HORSHAM DISTRICT COUNCIL CONSULTATION

TO:	Horsham District Council – Planning Dept
LOCATION:	Land North of Guildford Road Bucks Green Rudgwick West Sussex
DESCRIPTION:	Outline Planning Application for up to 90 no. residential dwellings (including 40% affordable) all matters to be reserved apart from access.
REFERENCE:	DC/25/1269
RECOMMENDATION:	<p>Modification / More information Holding objection / Modification More information / Modification</p> <p>No objection (modifications required to discharge the deemed biodiversity gain condition)</p>

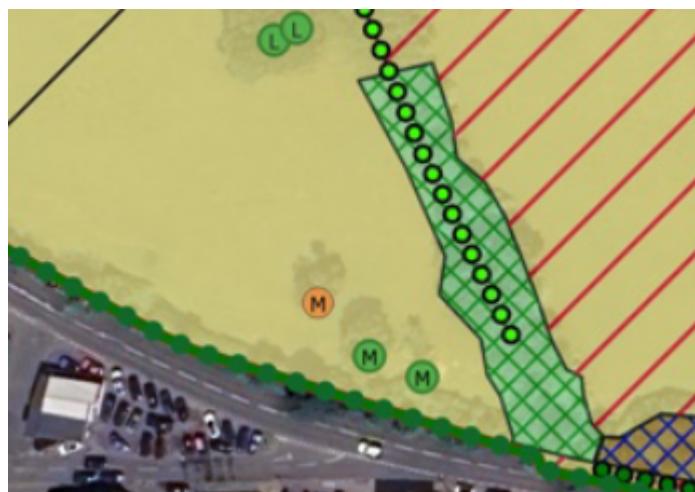
2.1 As per the Preliminary Drainage Strategy (Appendix A, Paul Basham Associated Ltd, 2025), an attenuation crate is proposed to be installed in the south of the site and appears to be very close to the retained hedgerow. Please can confirmation be sought as to whether impacts on this hedgerow will be avoided.

The ecologist refers to attenuation basins, however the original comment refers to the attenuation crate – I have copied two extracts below to illustrate this point.

Having discussed with the HDC Arboricultural Officer, it is our view that the installation of the attenuation crate is not possible without hedgerow removal and encroaching on tree root barriers adjacent to the existing tree RPAs. Therefore, this will need amending – it is recommended to relocate the attenuation crates or remove the 2-3 plots to the west of the proposed crate to provide sufficient space for installation. A minimum 1.5m distance is required for installing underground crates near hedgerows. Any forecast hedgerow removal will need to be accounted for within the metric.

The agent has confirmed an additional attenuation crate has been inserted in the system 'up stream' of the one located on the boundary. This is located under the car parking area of Unit 28. This has allowed the crate by the boundary to be re-sized so that it keeps 1.5m minimum from the hedgerow. An updated drainage strategy has been submitted to illustrate these changes. The increased 1.5m distance from the hedgerow is welcome. However, the concerns relating to installation of the attenuation crate and encroaching on tree root barriers still stand. Therefore, the retention of this tree remains uncertain.

Attenuation creates abutting tree RPAs and hedgerow.

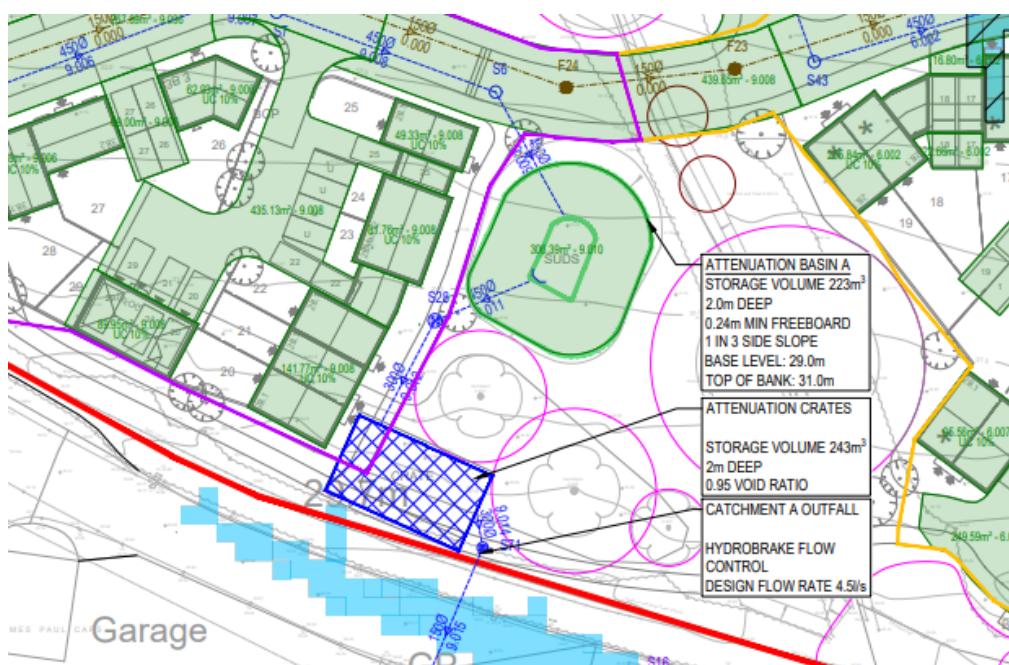
[^]Hedgerow lining southern boundary on site, as per Figure 4 in BNG Report.
